Access Compliance Report

Public Rights-of-Way

Intersection ID: 48495	Main Street: LOCH_LOMOND_DR	Cross Street: BEREWICK_COMMONS_PY	Location: W
ADA ID: 9FB462FCBBD8	Ramp Type: PerpDiag	Initial Pass/Fail: Fail	Overall Compliance: No
Severity Score: 8.75			
Codes/Mitigation Info/Possible Solution		Field Measurements/Component Compliance

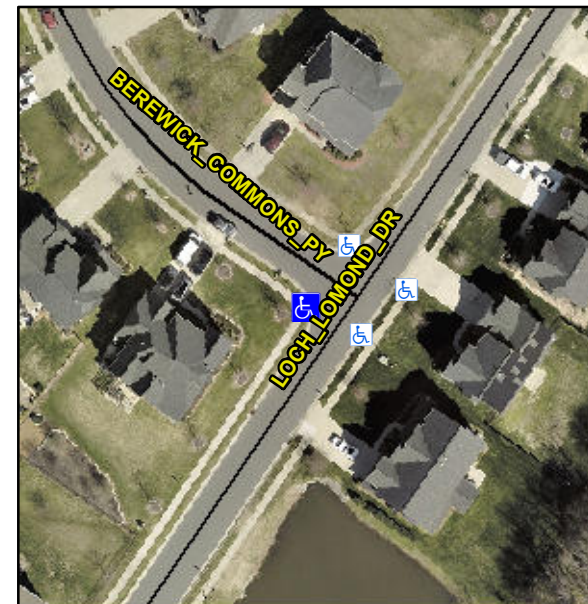
R304.5.1

Compliance	Description	Data	Compliance	Description	Data
N/A	Ramp Length (in)	48.0	Yes	Ramp Slope (%)	5.2
No	Ramp Width (in)	47.0	Yes	Ramp XSlope (%)	0.4
N/A	Flare Type LT	N/A	N/A	Flare Type RT	N/A
N/A	Flare Slope LT (%)	N/A	N/A	Flare Slope RT (%)	N/A
N/A	Flare Traversable LT?	N/A	N/A	Flare Traversable RT?	N/A
N/A	Landing Length (in)	N/A	N/A	DWS Provided?	N/A
N/A	Landing Width (in)	N/A	N/A	DWS Contrast?	N/A
N/A	Landing Slope (%)	N/A	N/A	DWS Length (in)	N/A
N/A	Landing X Slope (%)	N/A	N/A	DWS Full Width?	N/A
N/A	Landing Curb? (Y/N)	N/A	N/A	DWS Offset (in)	N/A
N/A	Shared Landing?	N/A			
N/A	Gutter Ponding?	N/A	N/A	Gutter Slope (%)	N/A
N/A	Gutter Lip Ht (in)	N/A	N/A	Gutter X Slope (%)	N/A
N/A	Painted X Walk1?	No	N/A	Painted X Walk2?	No
	X Walk 1 Direction	To SE		X Walk 2 Direction	To NE
N/A	X Walk 1 Width (in)	N/A	N/A	X Walk 2 Width (in)	N/A
	X Walk 1 Slope (%)	3.0		X Walk 2 Slope (%)	0.1
	X Walk 1 X Slope (%)	0.8		X Walk 2 X Slope (%)	0.1

Remove & Replace Curb Ramp With Two New Directional Ramps or Equivalent.
